Access Compliance Report

Public Rights-of-Way

Intersection ID: 16072	Main Street: MONROE_RD	Cross Street: RICHLAND_DR	Location: SW
ADA ID: 817A0BF257DE	Ramp Type: Perp	Initial Pass/Fail: Fail	Overall Compliance: No
		Severity Score: 10

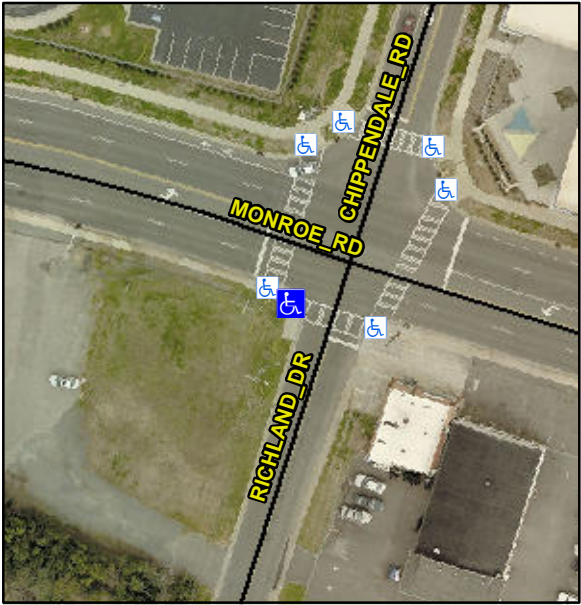
Codes/Mitigation Info/Possible Solution			Field Measurements/Component Compliance		
	Possible Solutions:		Compliance	Description	Data
	Remove & Replace Entire Ramp.		N/A	Ramp Length (in)	72.0
			No	Ramp Width (in)	40.5
			N/A	Flare Type LT	N/A
			N/A	Flare Slope LT (%)	N/A
			N/A	Flare Traversable LT?	N/A
			N/A	Landing Length (in)	N/A
			N/A	Landing Width (in)	N/A
			N/A	Landing Slope (%)	N/A
			N/A	Landing X Slope (%)	N/A
<p>Surveyor Notes:</p> <p>N/A</p> <p>PROW/ADA:</p> <p>Not Found, R304.5.1</p>			N/A	Flare Type RT	N/A
			N/A	Flare Slope RT (%)	N/A
			N/A	Flare Traversable RT?	N/A
			N/A	DWS Provided?	N/A
			N/A	DWS Contrast?	N/A
			N/A	DWS Length (in)	N/A
			N/A	DWS Full Width?	N/A
			N/A	DWS Offset (in)	N/A
			N/A	Gutter Ponding?	N/A
			N/A	Gutter Lip Ht (in)	N/A
			N/A	Painted X Walk1?	Yes
				X Walk 1 Direction	To E
			N/A	X Walk 1 Width (in)	115.0
				X Walk 1 Slope (%)	2.8
				X Walk 1 X Slope (%)	3.5
			N/A	Ramp inside XWalk1?	Yes

Road Slope (%)	N/A
				Road X Slope (%)	N/A
			N/A	Any Obstructions?	N/A
				Obstruction Type	
Total Cost: \$ 1850.00					
			N/A	Clear Space?	N/A
				Clear Space to XWalk (in)	N/A
			N/A	Storm Grate/Utility Hazard?	N/A
				Storm Grate/Utility Type	
			N/A		N/A
			Yes	Surface Condition? (G/P)	Good
